SECTION 00 9113.02 - ADDENDUM #2

- A. Project Name: **Water & Sewer Building.**
- B. Owner: **City of Minot.**
- C. Architect: **Ackerman-Estvold, Engineering & Management Consulting, Inc.**
- D. Architect Project Number: **R25132.**
- E. Date of Addendum: **February 26th, 2026.**

ADDENDUM NO. C-1

STRUCTURAL ADDENDUM S-1:

SHEET
S101
 FOUNDATION PLAN

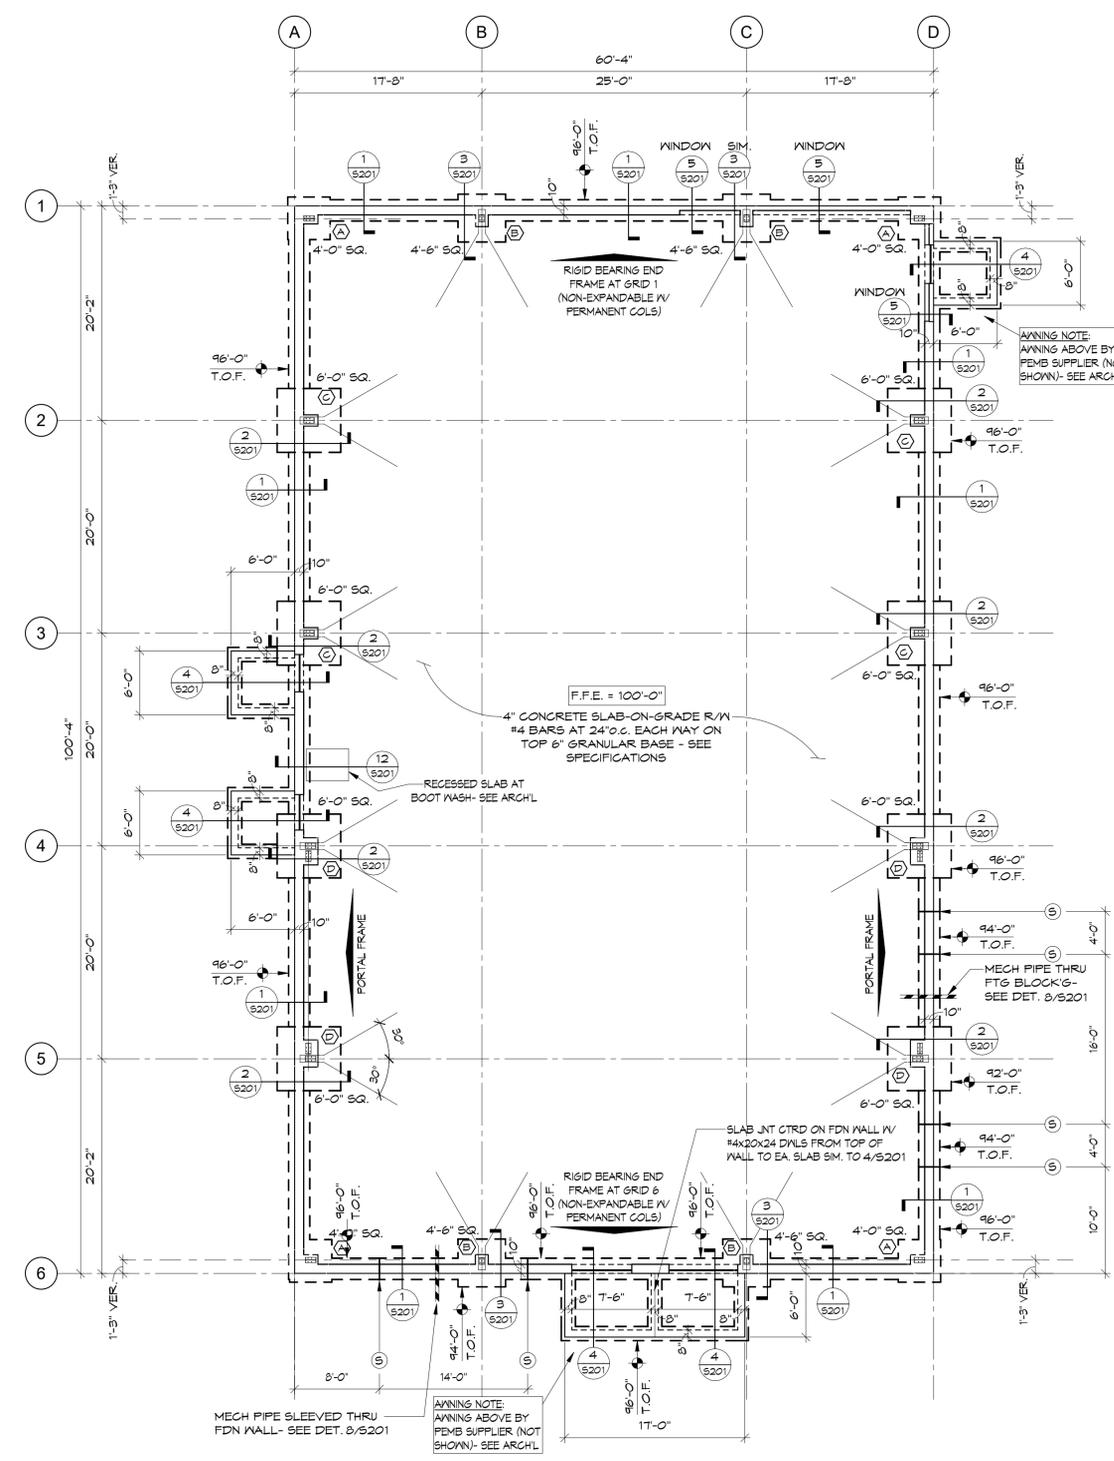
1. Sheet S001
 - a. General Structural Notes
 - i. Foundations Section – Notes #1 is to be updated to reference the Geotechnical Report by Material Testing Services.
 - ii. Foundations Section – Notes #2 is to be updated to reference the Geotechnical Design values and overexcavation requirements as indicated in the supplied Geotechnical Report.
2. Sheet S101
 - a. The Soils Box Note is to be updated to reference the associated Geotechnical Report by Materials Testing, the & the overexcavation requirements as indicated in the supplied Geotechnical Report.
 - b. The pad footing schedule
 - i. The soil bearing capacity is to be 2000 psf.
 - ii. The 6'-0" square pad footing is to be 14" thick in lieu of 12" thick.

1 FIRST FLOOR PLAN
A101 1/8" = 1'-0"

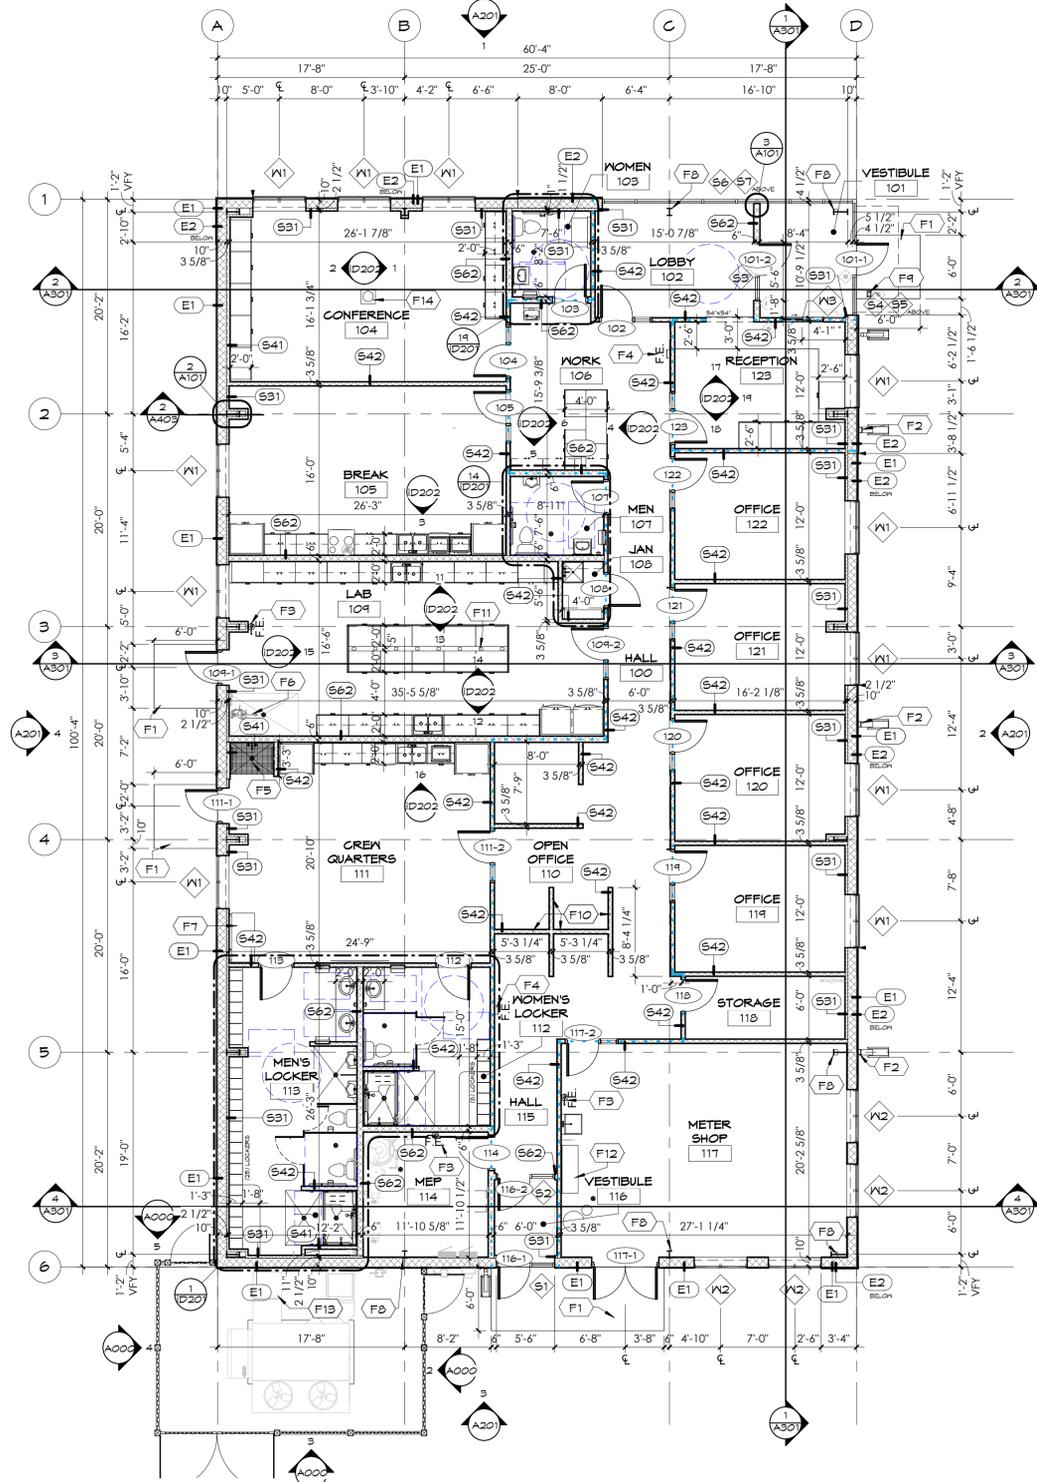
- A. Sheet G300 – Assembly Types (reissued).
 1. Roof Types: Clarified dimensions on graphics to match notes on roof type RA.
- B. Sheet A101 – Floor Plan (reissued).
 1. Drawing 1/A101: Add dashed lines indicating window treatments at the W2 window locations in the meter shop.
 2. Floor Plan General Note #3: Revise to read "Dashed line @ W1 & W2 windows..." In lieu of "Dashed line @ W1 windows..."
- C. Sheet iD100 – Finish Plans & Schedule (reissued).
 1. Room Finish Schedule: Omit "PAINT-2" notes for the soffits at rooms 101 & 102. Add Remark #2 for room 102.
- D. Sheet iD300 – Casework Details (not reissued).
 1. Drawing 19/iD300: Revise text below the "SA-3" note to read "Non-illuminated room plaque" in lieu of "non-illuminated acrylic room plaque."
